TOWN OF RAYMOND

Planning Board Agenda

- a) **Application # 2021-011:** An amended site plan application is being submitted by Jacob Doerfler of The Dubai Group, Inc. on behalf of Mega-X. They are proposing to add a scale and more truck parking. The property is represented as Raymond Tax Map 22/ Lot 9-1 and located on Old Manchester Road.

Memo To: Town of Raymond Planning Board
From: Madeleine DiIunno, Regional Planner, Rockingham Planning Commission
Date: September 10, 2021
Subject: Review of Application 2021-011: Site Plan Application – Mega-X Old Manchester Road (Tax Map 22 Lot 9)

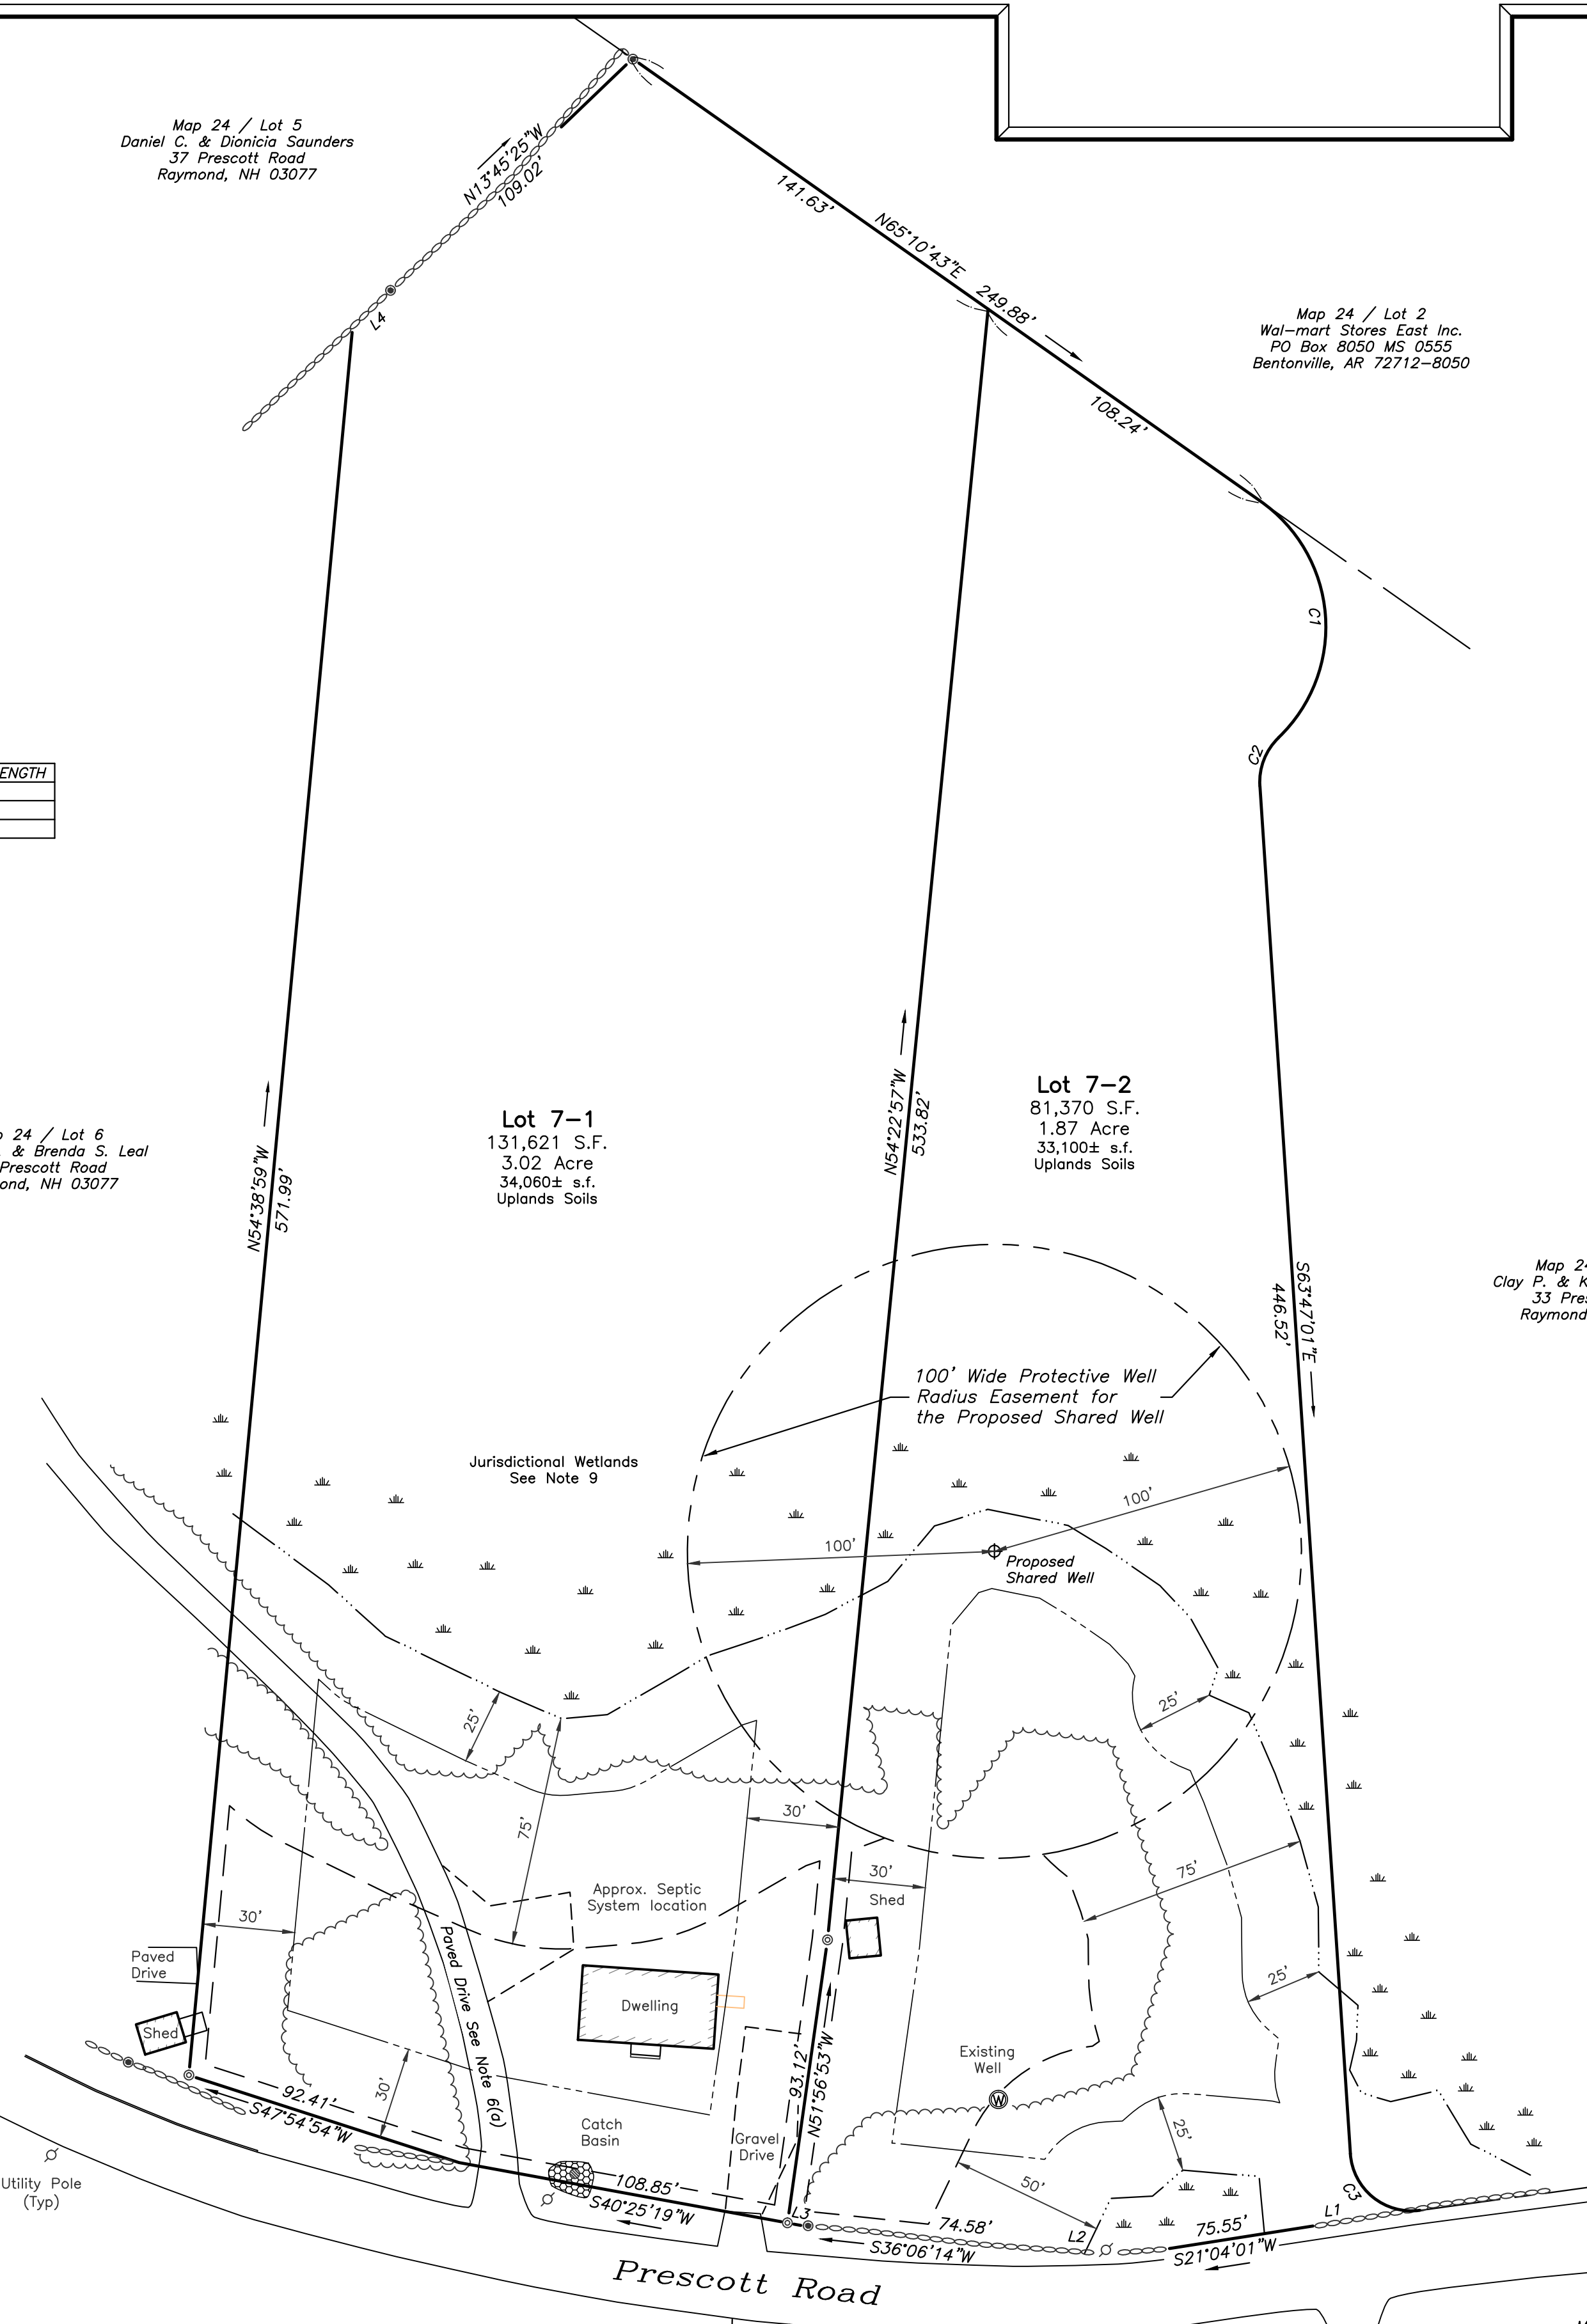
4. Sheet 3 shows something attached to the existing Duplex within the 30' setback. Is this a structure? If so, it does not meet Zoning.
5. The northwesterly end of the new lot line needs to indicate type of monument to be set (or has been set)
